Service Bulletin

No. : MZ07-052

Model: SR7500, SR8500

Subject: Software Update

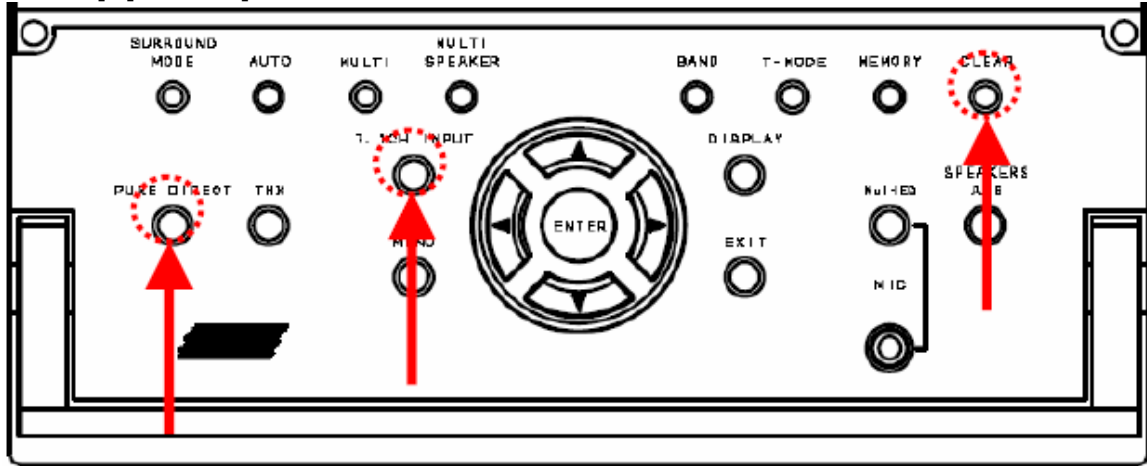
Symptom: Update the software to minimize component over dissipation when the power amp has failed.

Before Updating:

Originally, the unit was designed to go into STANDBY mode with the STANDBY LED flickering every 500m sec. upon detection of an abnormality. The unit would never be powered on by the standby switch or the remote control, so over dissipation never occurred. However, if the unit was unplugged and plugged in again, component over dissipation could occur before the unit went into standby a few seconds later.

After Updating:

The unit has been modified never to be powered on by any means once it goes into standby with the standby led flickering every 125m sec., unless a specialized procedure (*1 described below) is performed.
